| Report No   | PLN/046/26 |

**Report Title:** 25/02543/FUL: Mr Matt Baron  
Tigh Deas, 20 Camuslongart, Dornie, Kyle, IV40 8EX

**Report By:** Area Planning Manager - North

**Description:** Demolition of house and erection of garage with ancillary annex accommodation, including installation of balcony

South Elevation

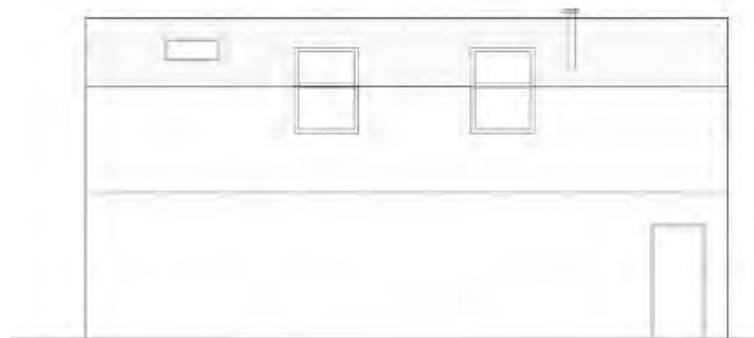
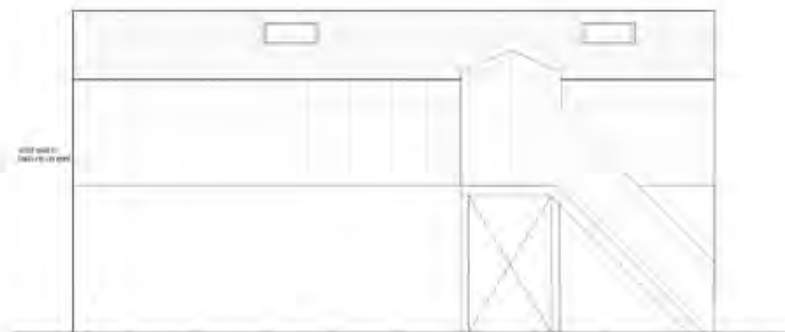
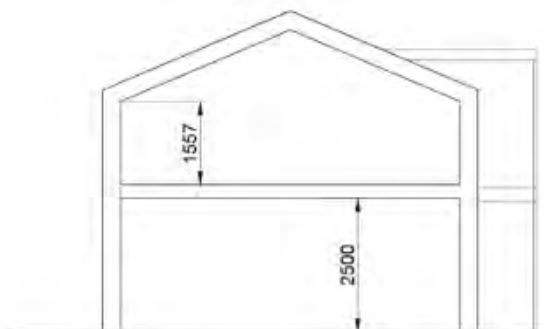
- 8.15 Although the proposal has been amended from the initial design incorporating a mono-pitched roof, the revisions do not overcome the Planning Authority's fundamental concerns regarding massing and design. Throughout the application process, the applicant has been advised that a building exceeding a single-storey height would not be supported in this location. This concern relates not only to the roof form but also to the overall relationship of the proposed building with its immediate context.

- 8.16 The proposed two-storey form, together with its elevated eaves, broad gable and shallow roof pitch, results in a building that appears overly dominant when viewed alongside the neighbouring dwelling. While there is a variety of house types within the wider area, the immediate context is defined by the close visual and architectural relationship between the existing dwelling and Tigh Tuath. This pairing forms a distinctive and cohesive group, and any replacement or ancillary building should respect and reinforce that established character. The proposed design fails to do so and instead introduces a form and scale that is visually inappropriate within this immediate setting.

- 8.19 Taken as a whole, the proposed building, by reason of its excessive height, two-storey form, elevated eaves and overall massing, would appear out of place within its immediate context, failing to respect the established relationship between the existing buildings on the site and the neighbouring property. The proposal would consequently have an unacceptable adverse impact on the character and appearance of the area.

- 8.21 Although the proposed building would largely occupy the footprint of the existing house, it would extend approximately 2 metres further to the rear and, more significantly, would increase in overall height by approximately 0.9 metres compared with the existing building. While the footprint alterations are relatively modest, the cumulative effect of the increased height and extended massing would materially alter the relationship between the proposed dwelling and the neighbouring property, Tigh Tuath.

- 8.24 The proposed ancillary building would be positioned to the southwest of Tigh Tuath. Consequently, its increased height and massing have the potential to interrupt the path of the afternoon and evening sun, particularly during the autumn and winter months when the sun is lower in the sky. The existing dwelling (Tigh Deas) has a ridge height of approximately 5.1 metres. The proposed replacement building would increase this height by approximately 0.9 metres, resulting in a substantially taller built form immediately adjacent to the shared boundary. Given the limited separation distances and the southwestern position of the proposal relative to Tigh Tuath, the development would cast a greater shadow over the neighbouring property than the existing dwelling.

staircase by enclosing this element, which is a positive amendment. The proposal has been amended so that only rooflight-type windows are now proposed on the northern elevation, replacing the standard bathroom window that formed part of the original submission.

- 8.28 However, the proposal would still introduce a first-floor residential annexe with an enclosed balcony. Although the balcony is primarily orientated towards the main house owned by the applicant and located to the southeast, its elevated position would nonetheless allow views towards parts of the neighbouring garden, when occupants are using the balcony. It is considered that the proposal would increase opportunities for overlooking compared to the existing arrangement, resulting in an unacceptable erosion of the privacy currently enjoyed by the adjoining property. The development therefore fails to adequately safeguard neighbouring residential amenity and is contrary to the relevant policies of the development plan requiring new development to avoid unacceptable impacts on the privacy of adjacent occupiers.

1. The proposed ancillary building, by reason of its two-storey form, elevated eaves and overall massing, would fail to respect the established character, appearance and local distinctiveness of the immediate area or the close architectural relationship between the existing pair of houses (Tigh Deas and

2. The proposed ancillary building, by reason of its increased height, scale, proximity and position in relation to the neighbouring property, would result in unacceptable adverse impacts on the residential amenity of adjoining occupiers through increased overshadowing, loss of sunlight and overlooking. The proposal therefore fails to safeguard the amenity of neighbouring properties and is contrary to Policies 14 (Design, Quality and Place) and 16 (Quality Homes) of National Planning Framework 4, and Policies 28 (Sustainable Design) and 29 (Design Quality and Place-making) of the Highland wide Local Development Plan.

| Drawing    | Proposed Retaining Wall |

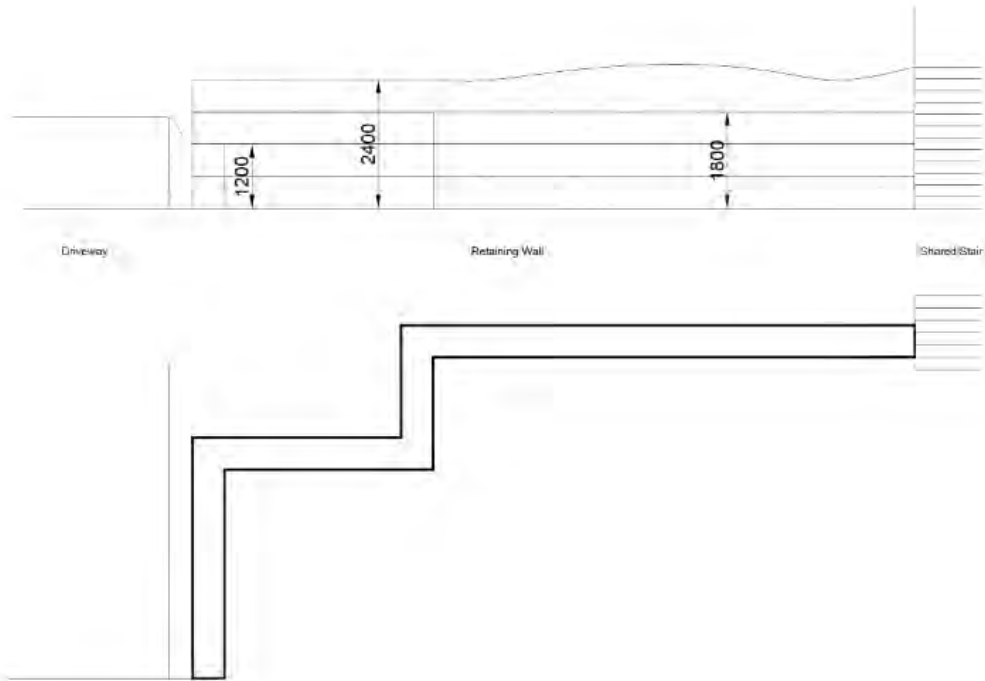
- 8.31 **Retaining wall** – Engineering works have been undertaken within the front garden to construct a retaining wall and create an area of hardstanding. The applicant initially regarded these works as site improvements and upgrades that did not require planning permission. However, once advised that planning permission may be required, the works were incorporated into the current application for assessment.

- 8.32 The retaining wall has been constructed to improve the stability of the steep embankment adjacent to the public road. It is formed using concrete blocks of varying lengths and reaches a maximum height of approximately 2.4 metres. The works also include the construction of improved pedestrian access steps, which are shared with

the neighbouring property, Tigh Tuath. These engineering works are considered acceptable.
